Intel[®] Pentium[®] 4 Processor in 478-pin Package and Intel[®] 845 Chipset Platform for SDR

Design Guide Update

March 2004

Document Number: **250425-003**

Figure 1, Top signal layer before the ground fill near the I/O area

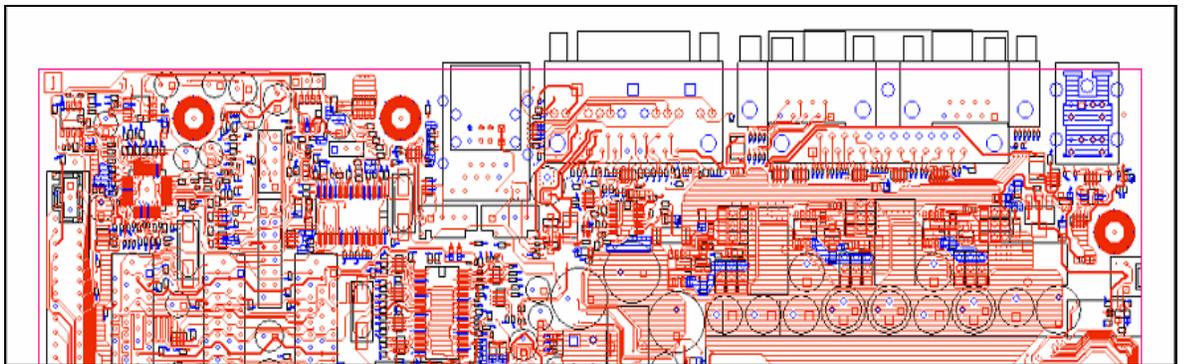
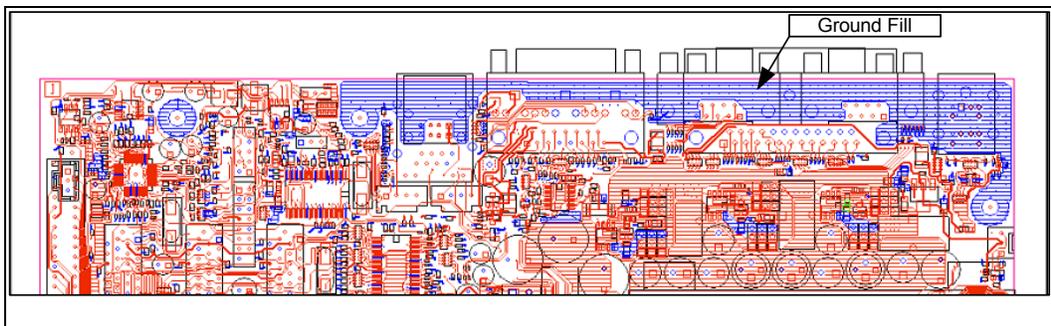
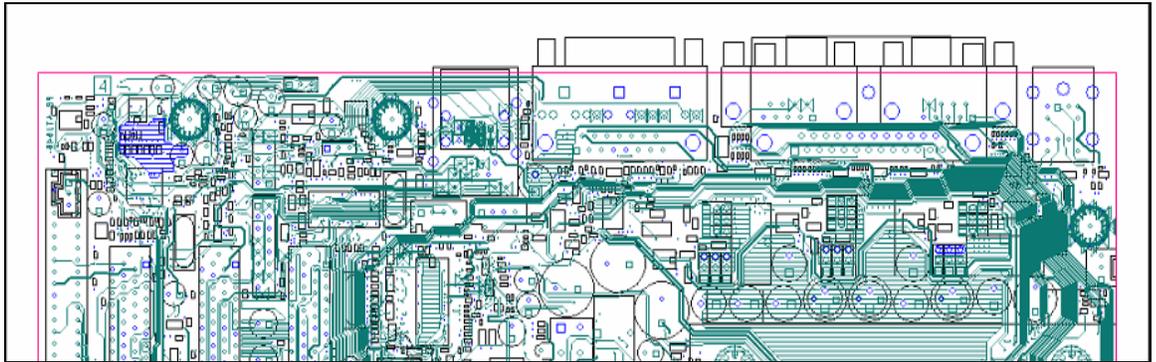
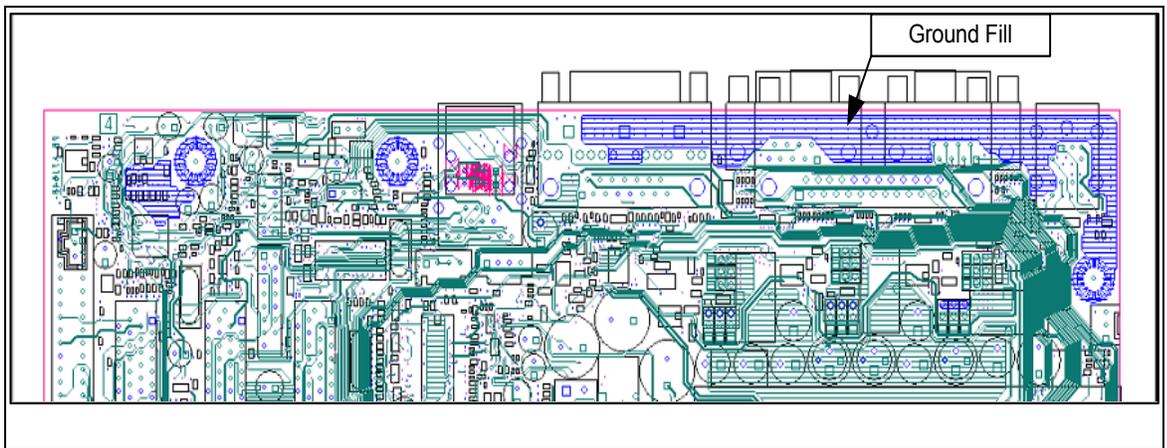
Intel recommends that the I/O area on the top and bottom signal layers of a 4-layer motherboard near the I/O back panel be filled with a ground fill as shown in Figures 1-4. In addition, a ground fill cutout should be placed on the Vcc layer in the area where the ground fill is done on the top and bottom layers. Intel recommends filling the I/O area as much as possible without effecting the signal routing. The board designer should fill the entire I/O area along the board edge.

The spacing from the ground fill to other shapes/traces should be at least 20 mils. It is recommended that these ground fill areas be connected to two chassis mounting holes (as seen in Figure 2). This will allow ESD current to travel to the chassis instead of the board. Ground stitching vias should be placed throughout the entire ground fill if possible. It is important that the vias are placed along the board edge. Ground stitching vias for the ground fill should be 100-150 mils apart or less.

In conclusion, Intel recommends the following:

- Fill the I/O area with the ground fill in all layers including signal layers whenever possible
- Extend the ground fill along the entire back I/O area
- Connect the ground fill to mounting holes
- Place stitching vias 100-150 mils apart in the entire ground fill
